Access Compliance Report

Public Rights-of-Way (Curb Ramps)

Intersection ID: 10015635	Main Street: HARRIS_CORNERS_PY	Cross Street: N/A	Location:	N
ADA ID: A3DBA5F48193	Ramp Type: BlendTrans2	Initial Pass/Fail: Fail	Overall Compliance: No	Severity Score: 8.75
Codes/Mitigation Info/Possible Solution		Field Measurements/Component Compliance

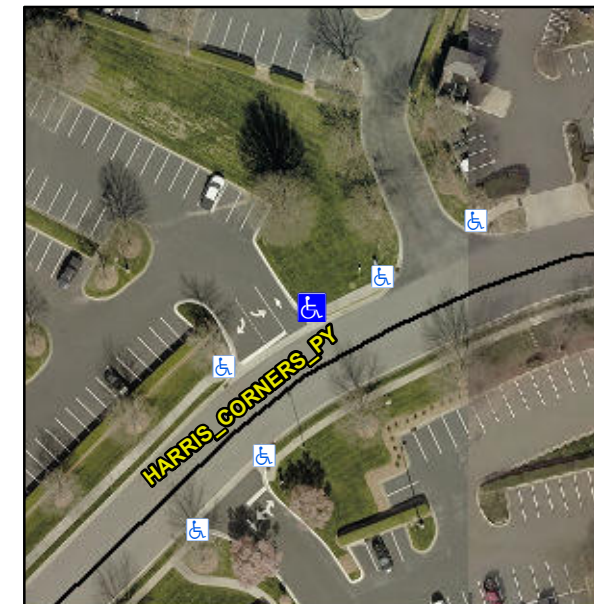
Compliance	Description	Data	Compliance	Description	Data
N/A	Ramp Length (in)	59.0	Yes	BlendTrans Slope (%)	0.4
No	Ramp Width (in)	40.0	Yes	BlendTrans XSlope (%)	1.9
N/A	Flare Type LT	N/A	N/A	Flare Type RT	N/A
N/A	Flare Slope LT (%)	N/A	N/A	Flare Slope RT (%)	N/A
N/A	Flare Traversable LT?	N/A	N/A	Flare Traversable RT?	N/A
N/A	Landing Length (in)	N/A	N/A	DWS Provided?	N/A
N/A	Landing Width (in)	N/A	N/A	DWS Contrast?	N/A
N/A	Landing Slope (%)	N/A	N/A	DWS Length (in)	N/A
N/A	Landing X Slope (%)	N/A	N/A	DWS Full Width?	N/A
N/A	Landing Curb? (Y/N)	N/A	N/A	DWS Offset (in)	N/A
N/A	Shared Landing?	N/A			
N/A	Gutter Ponding?	N/A	N/A	Gutter Slope (%)	N/A
N/A	Gutter Lip Ht (in)	N/A	N/A	Gutter X Slope (%)	N/A
N/A	Painted X Walk1?	No	N/A	Painted X Walk2?	No
	X Walk 1 Direction	To SW		X Walk 2 Direction	To S
	X Walk 1 Width (in)	N/A		X Walk 2 Width (in)	N/A
	X Walk 1 Slope (%)	0.5		X Walk 2 Slope (%)	0.8
	X Walk 1 X Slope (%)	0.6		X Walk 2 X Slope (%)	0.8

Remove & Replace Curb Ramp With Two New Directional Ramps or Equivalent.
